AS-BUILT

GRANT COUNTY PUBLIC WORKS
OFFICE/SHOP COMPLEX
EPHRATA, WA

OFFICE BUILDING - FOUNDATION & BASEMENT PLAN - PLUMBING

Sheet M2.1 OFFICE BUILDING - FOUNDATION & BASEMENT PLAN - PLUMBING

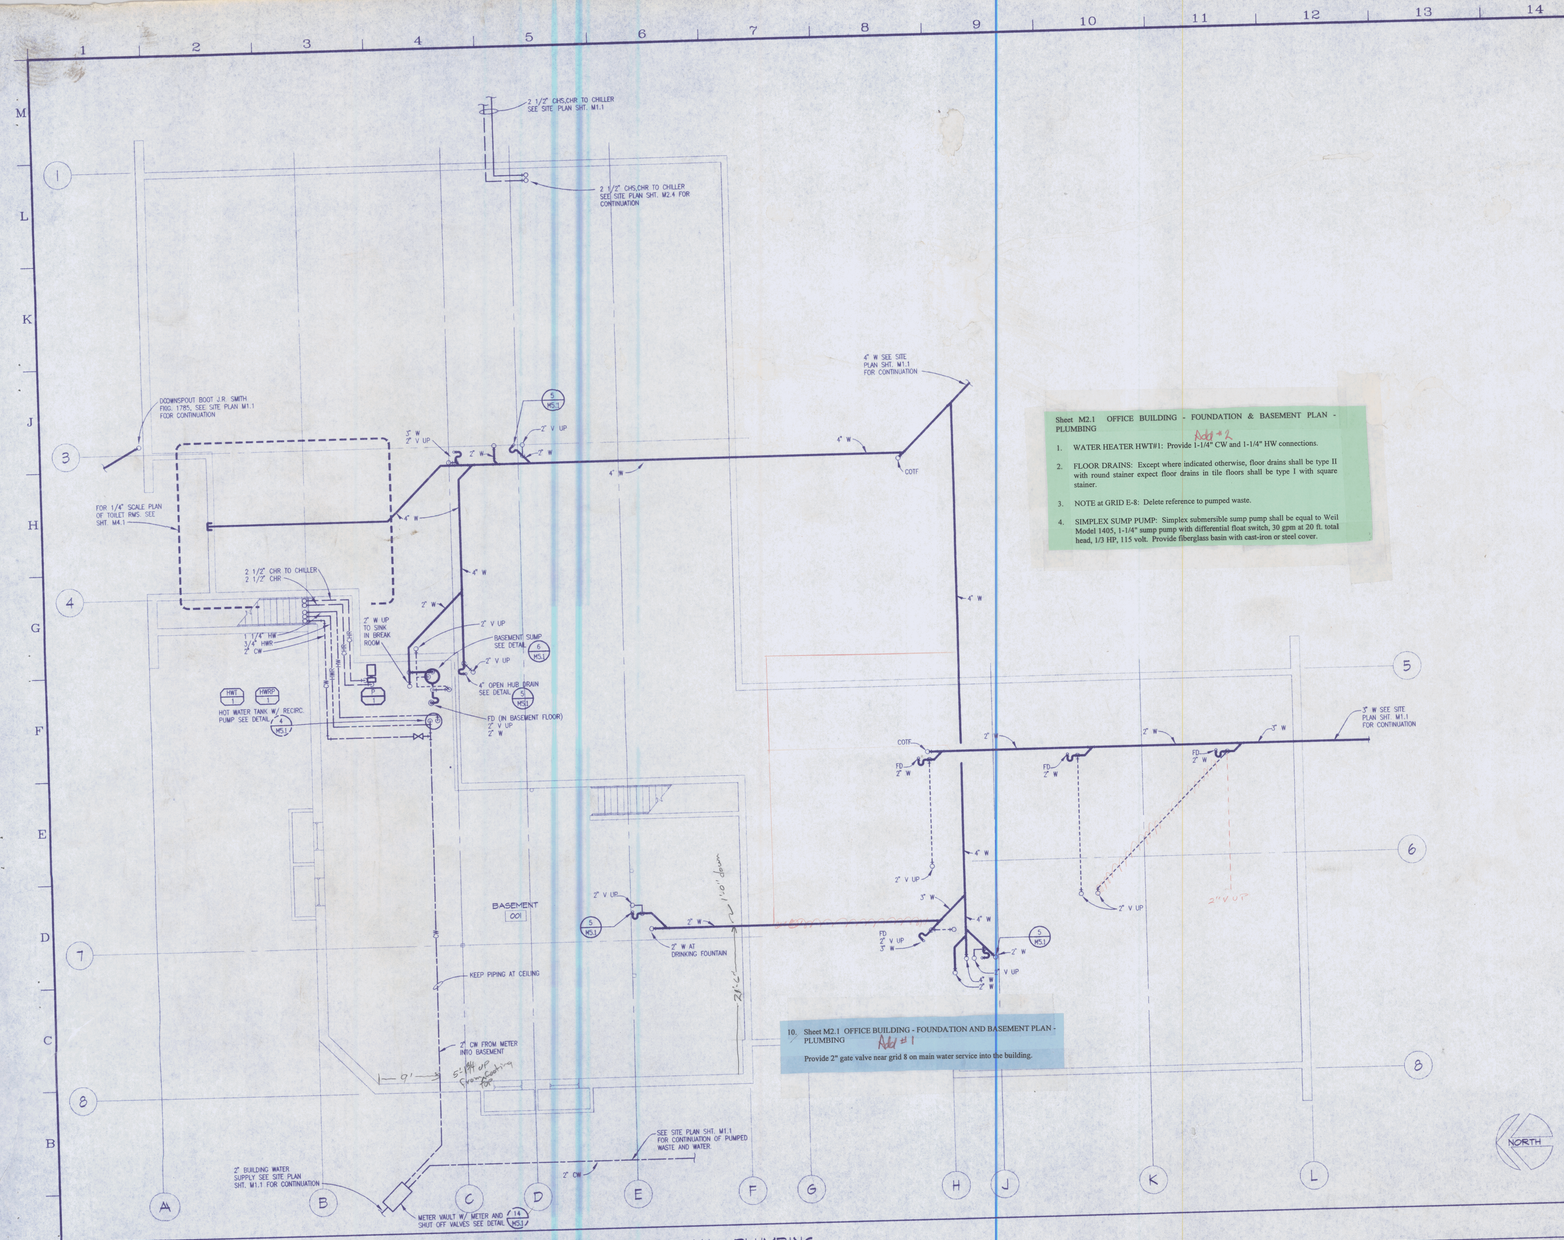
Add #2

1. WATER HEATER HWT#1: Provide 1-1/4" CW and 1-1/4" HW connections.
2. FLOOR DRAINS: Except where indicated otherwise, floor drains shall be type II with round stainer expect floor drains in tile floors shall be type I with square stainer.
3. NOTE at GRID E-8: Delete reference to pumped waste.
4. SIMPLEX SUMP PUMP: Simplex submersible sump pump shall be equal to Weil Model 1405, 1-1/4" sump pump with differential float switch, 30 gpm at 20 ft. total head, 1/3 HP, 115 volt. Provide fiberglass basin with cast-iron or steel cover.

Add #1

Provide 2" gate valve near grid 8 on main water service into the building.
